Agenda Item # 5 SUB-003019-2024

Resubdivision of Lot 3 and a portion of Lot 2, Block C,
Greenview Heights Subdivision

- Subdivision approval to create one (1) legal lot of record from one (1) metes-and-bounds parcel.

DETAIL SITE PLAN

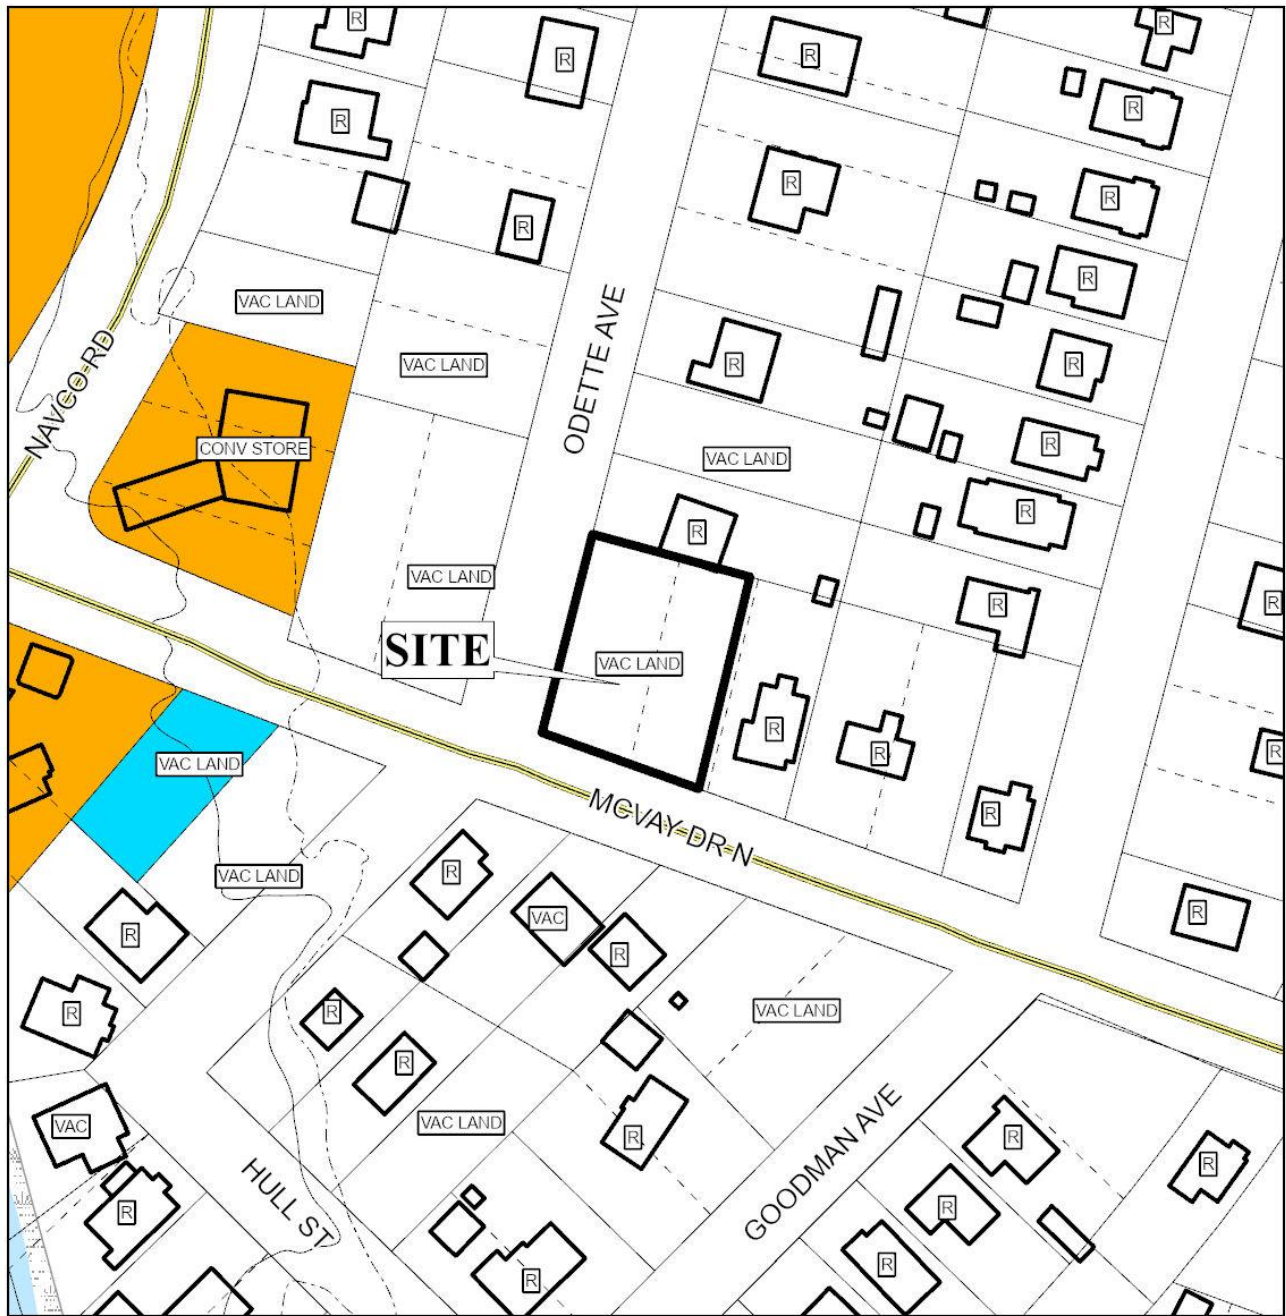
McVay Drive North is incorrectly labeled as McVay Drive. If approved, the plat should be revised to correctly label McVay Drive North.

The proposed lot is a corner lot requiring a 25-foot corner radius at the intersection of McVay Drive North and Odette Avenue, per Section 6.C.6. of the Subdivision Regulations. If approved, the plat should be revised to depict dedication of a 25-foot corner radius unless the Planning Commission approves a waiver of Section 6.C.6.

2. Revision of the plat to correctly label McVay Drive North;
3. Dedication of a 25-foot corner radius at the intersection of McVay Drive North and Odette Avenue, in compliance with Section 6.C.6. of the Subdivision Regulations;
